PLYMOUTH CO. RCB CULVERT REPLACEMENT - TWIN BOX
BRFN-003-1(95)--39-75
 LETTING DATE
DEC. 17, 2019

RCB CULVERT REPLACEMENT - TWIN BOX

PRELIMINARY PLANS

QUESTIONS & COMMENTS

Resurfacing 10-19-10	
STATION TO STATION	
175+80.00	178+23.10
178+55.10	180+80.00

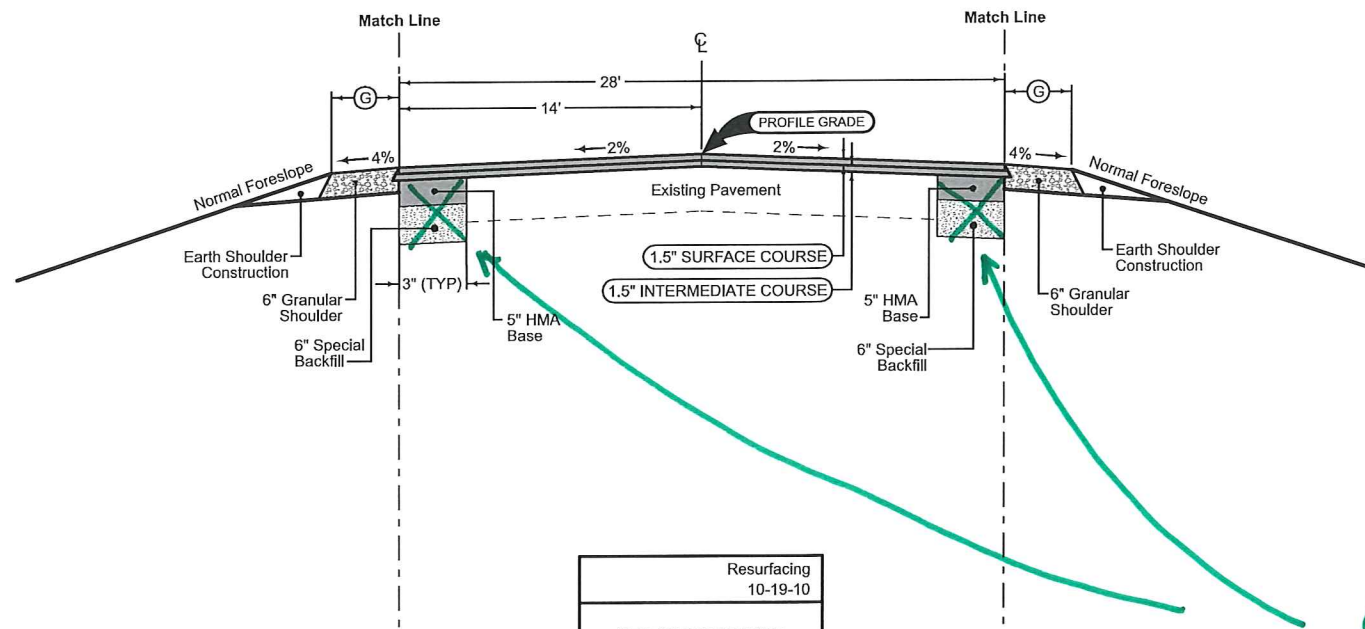
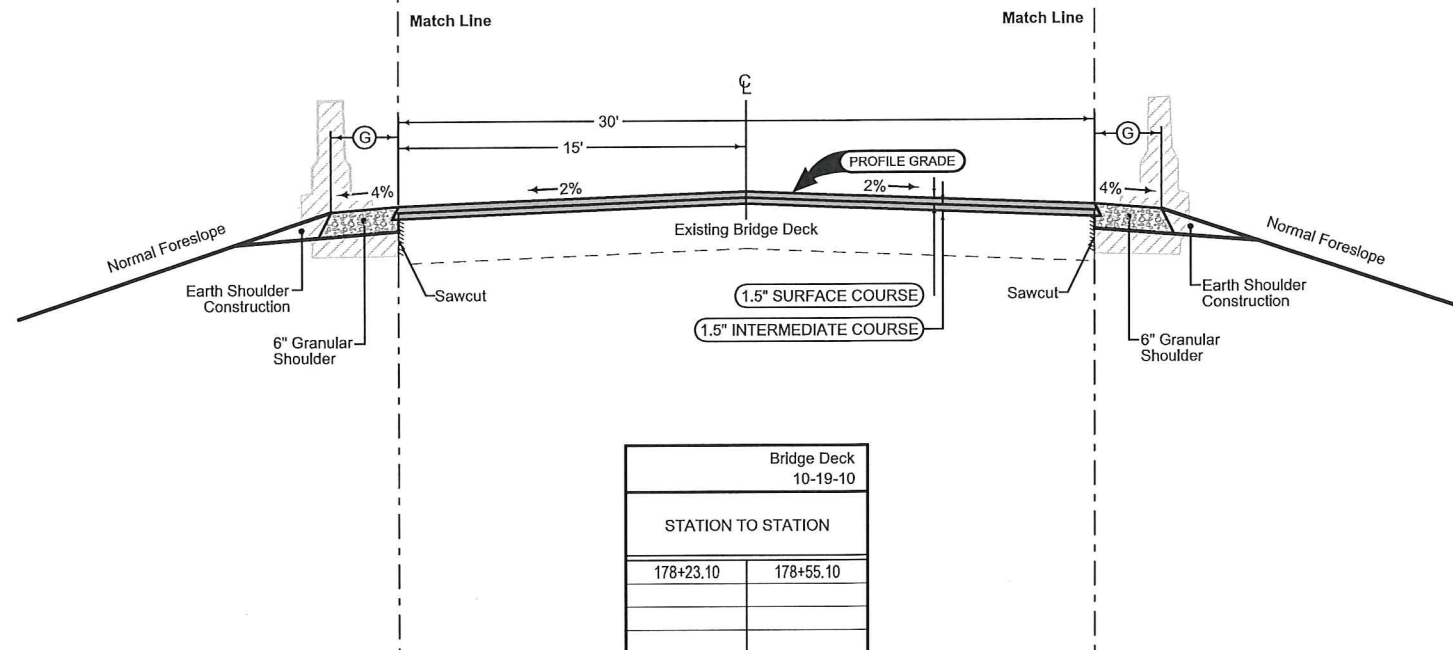
*Widening work was completed
Therefore this can be removed*

FILE NO.	ENGLISH	DESIGN TEAM	FLATTERY \ Manc1 \ Crystal	PLYMOUTH COUNTY	PROJECT NUMBER	BRFN-003-1(95)--39-75	SHEET NUMBER	D.3
----------	---------	-------------	----------------------------	-----------------	----------------	-----------------------	--------------	-----

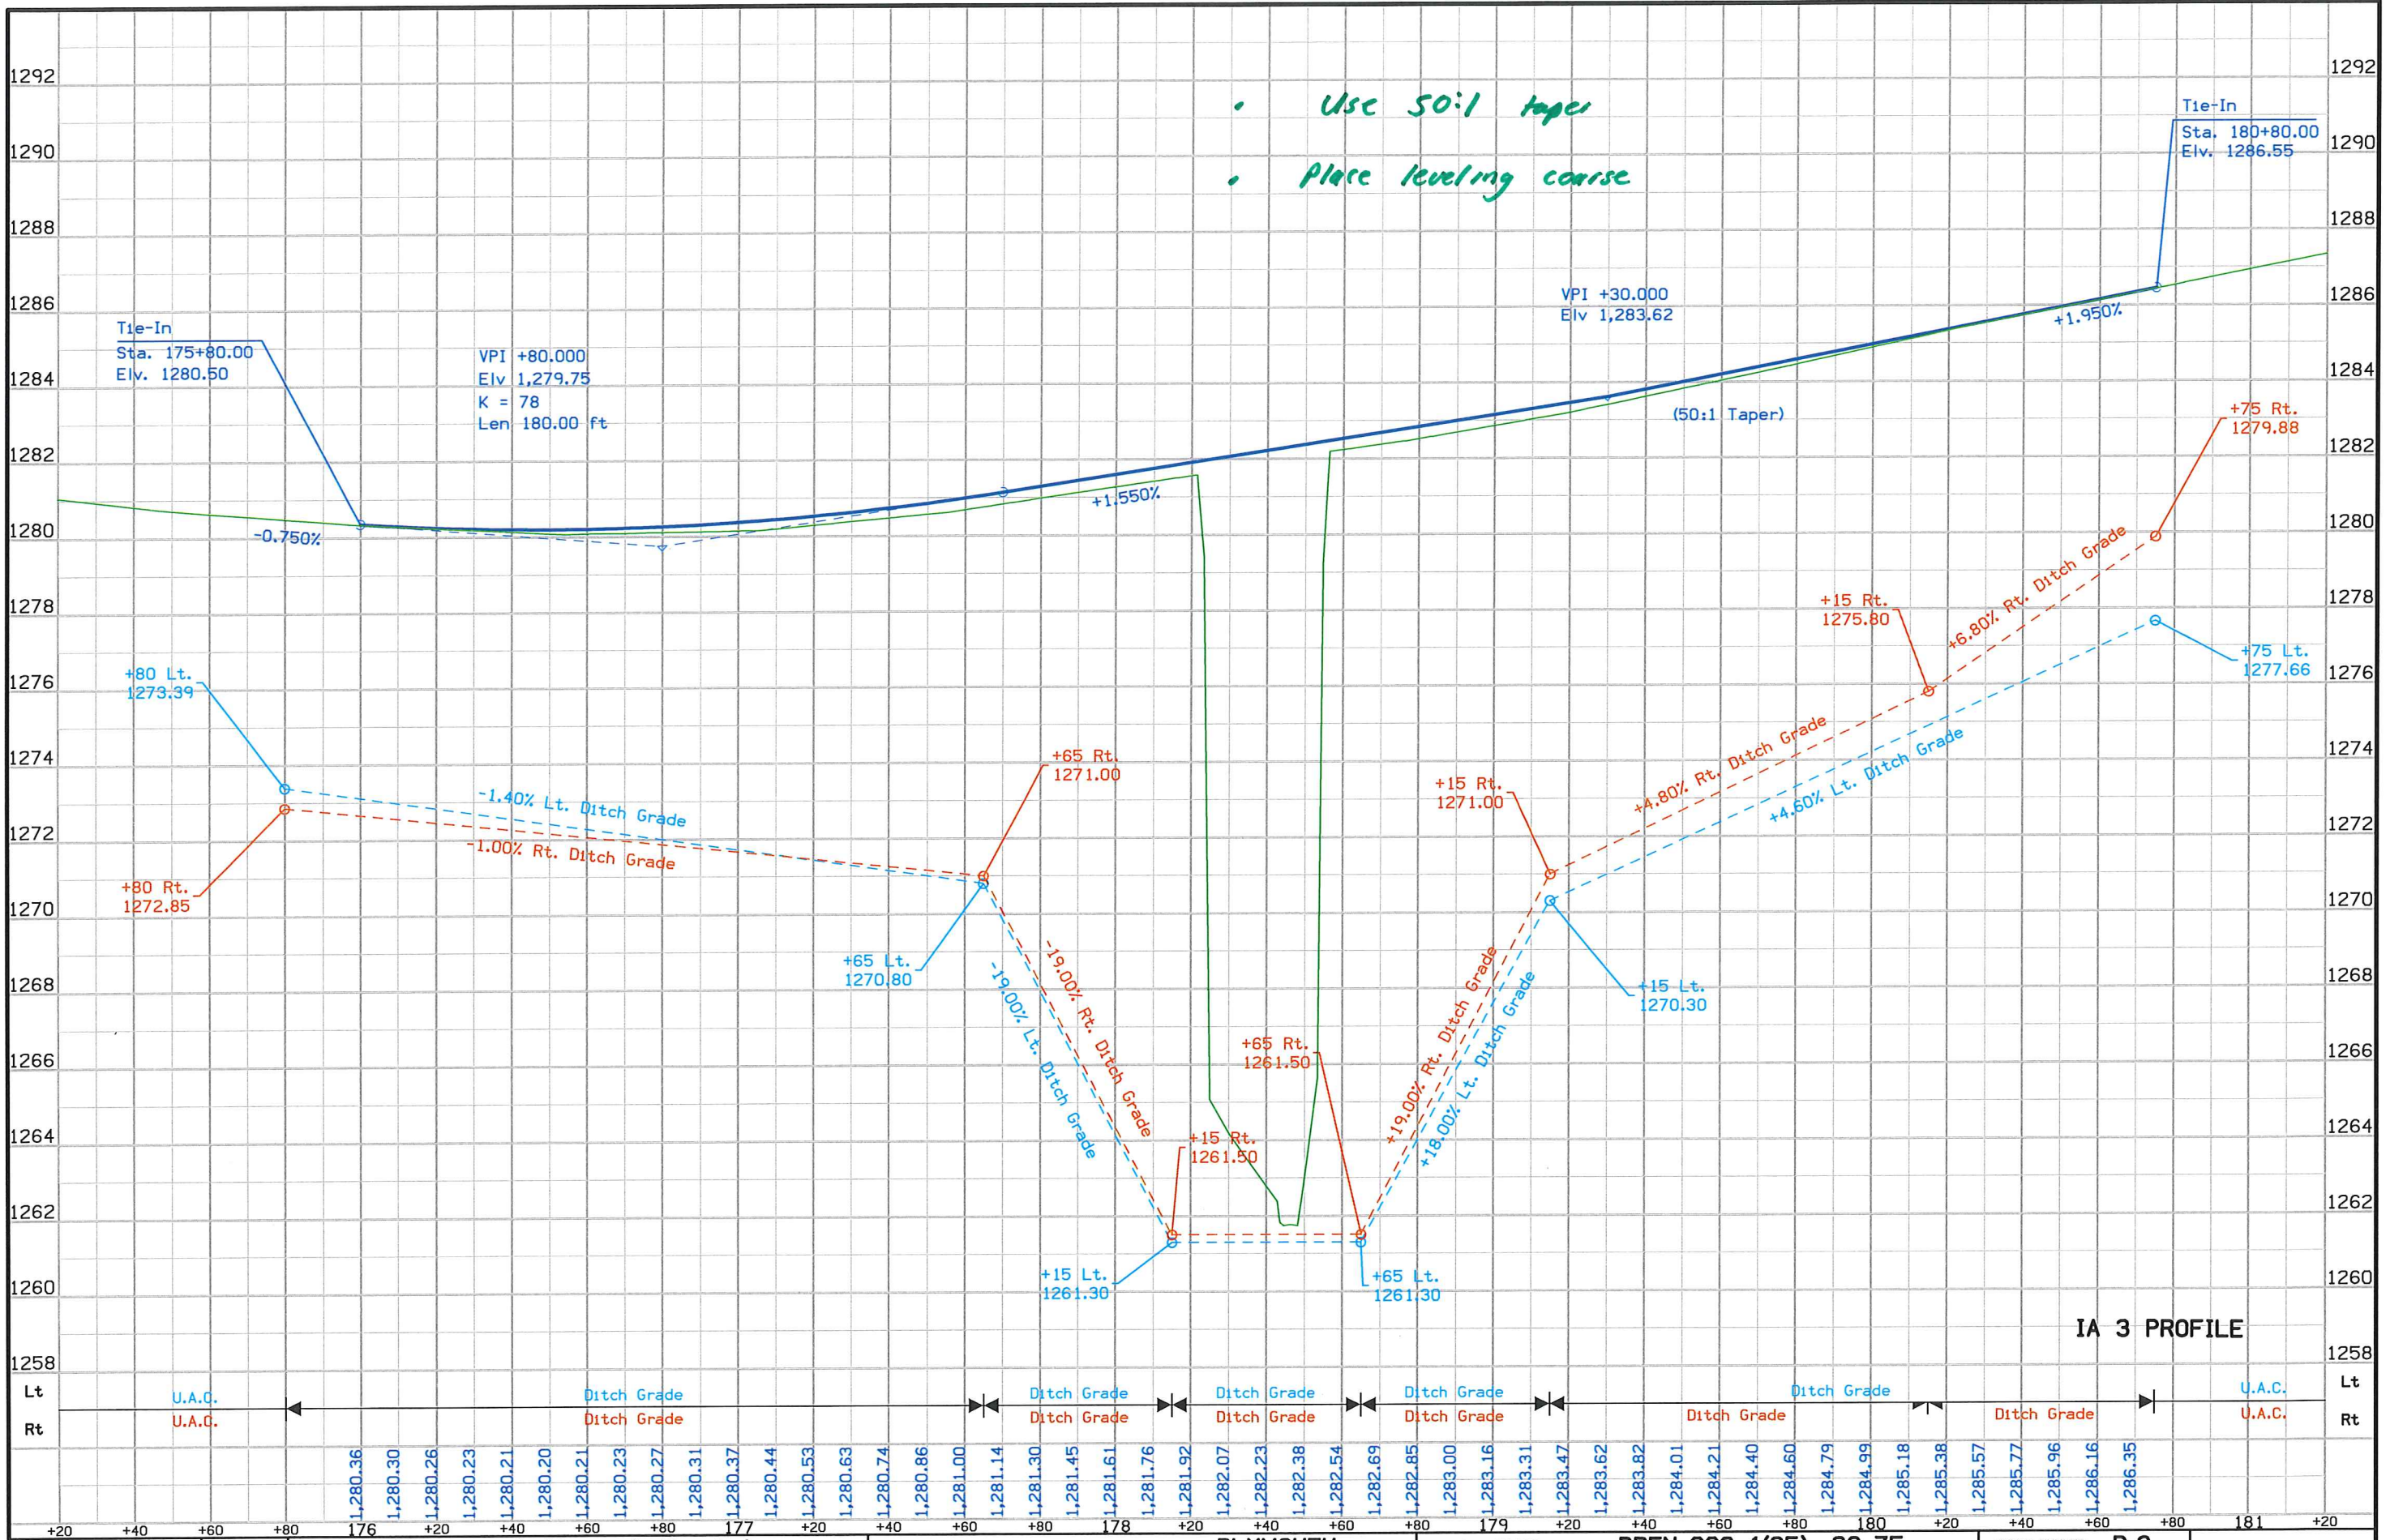
*Fiber optic lines
will need to be relocated*

• Use 50:1 taper
 • Place leveling course

D2
 DESIGN FOR 0° SKEW
**TWIN 12'-0 X 12'-0 X 104'-0
 CAST-IN-PLACE CONCRETE CULVERT**
 SITUATION PLAN
 STATION 178+39.05 JUNE 2017
 PLYMOUTH COUNTY
 IOWA DEPARTMENT OF TRANSPORTATION - HIGHWAY DIVISION
 DESIGN SHEET NO. OF ? FILE NO. ? DESIGN NO. ?

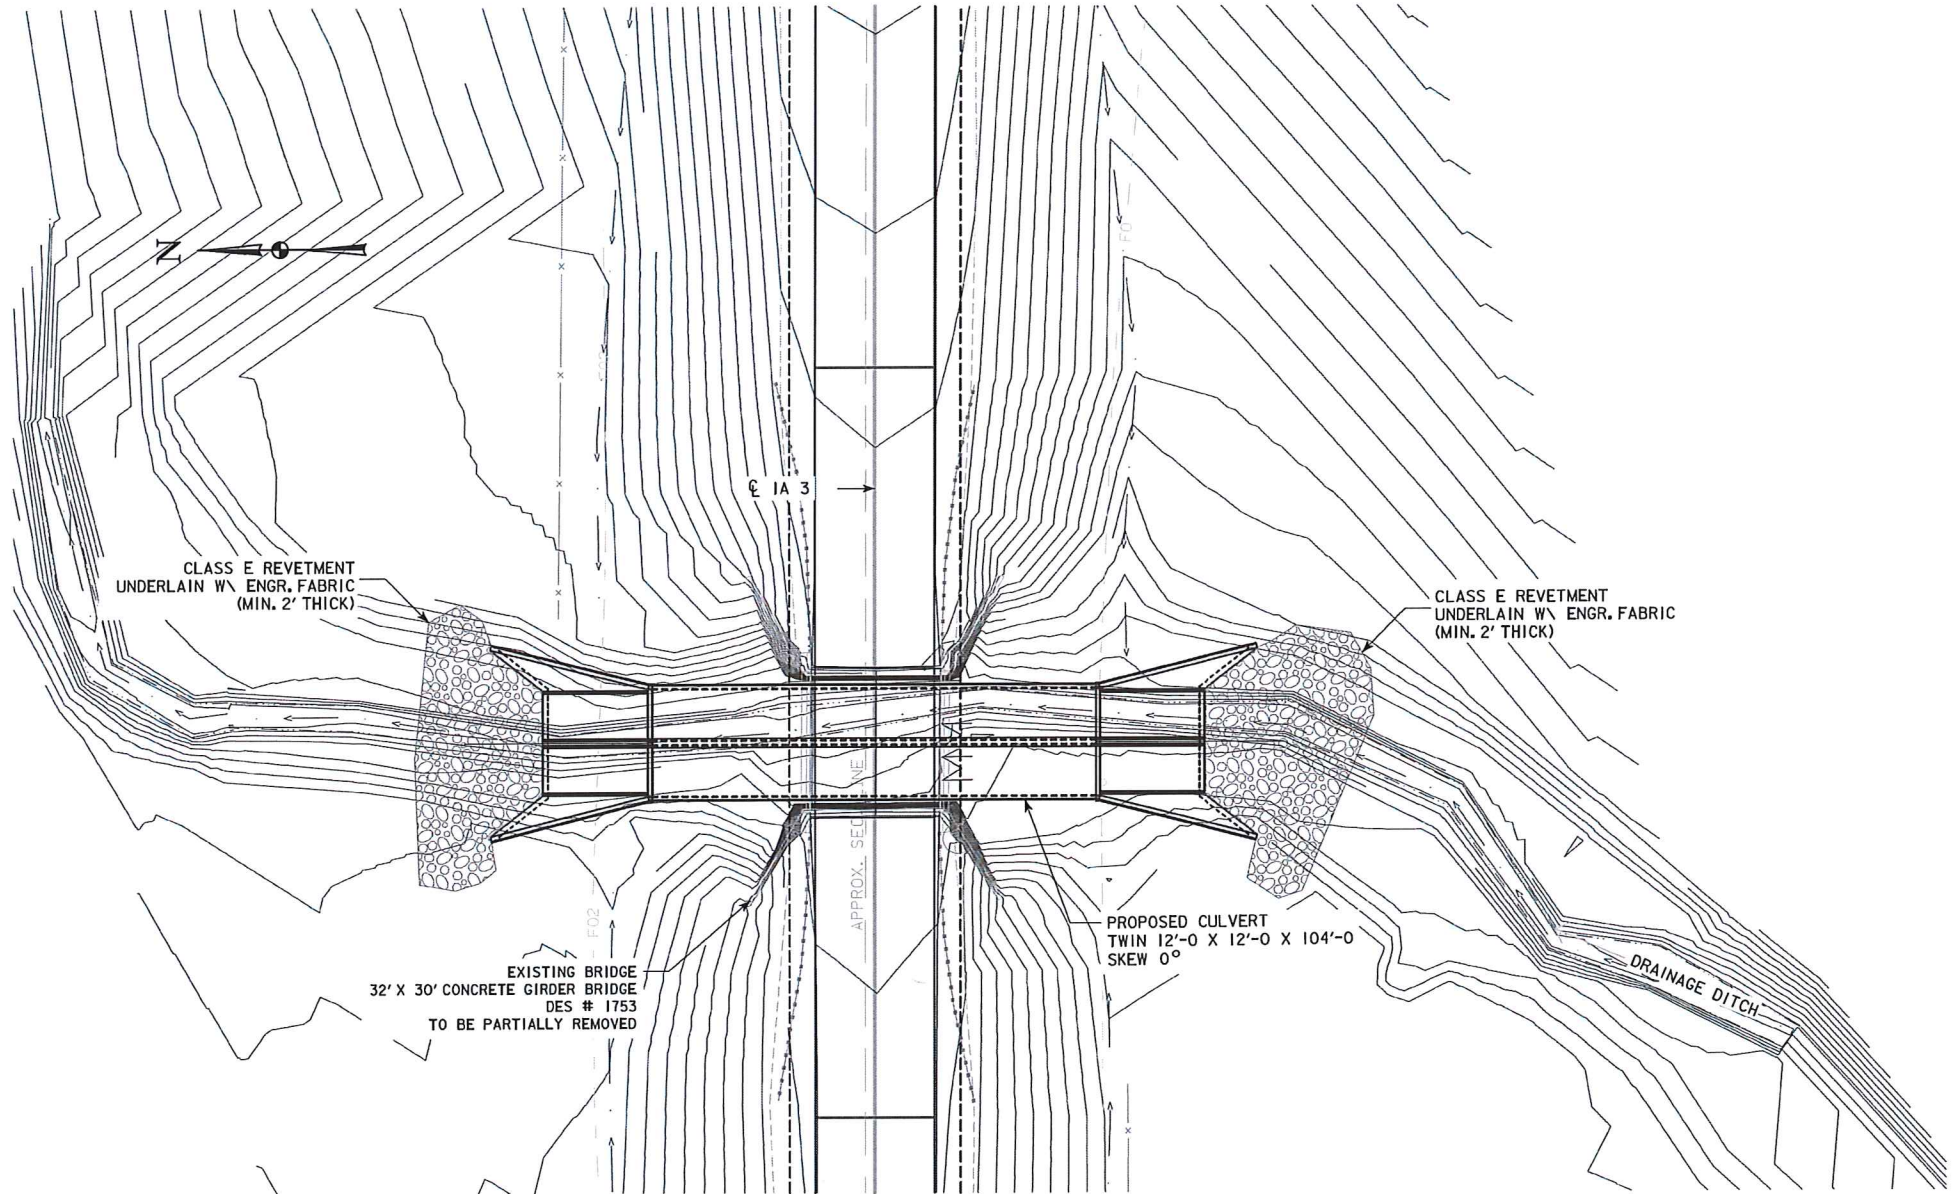
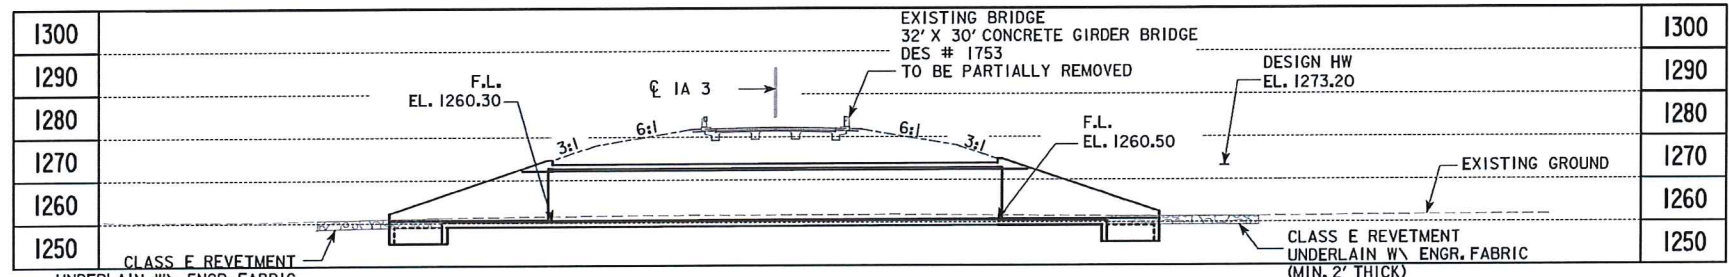
Pre Cast option also
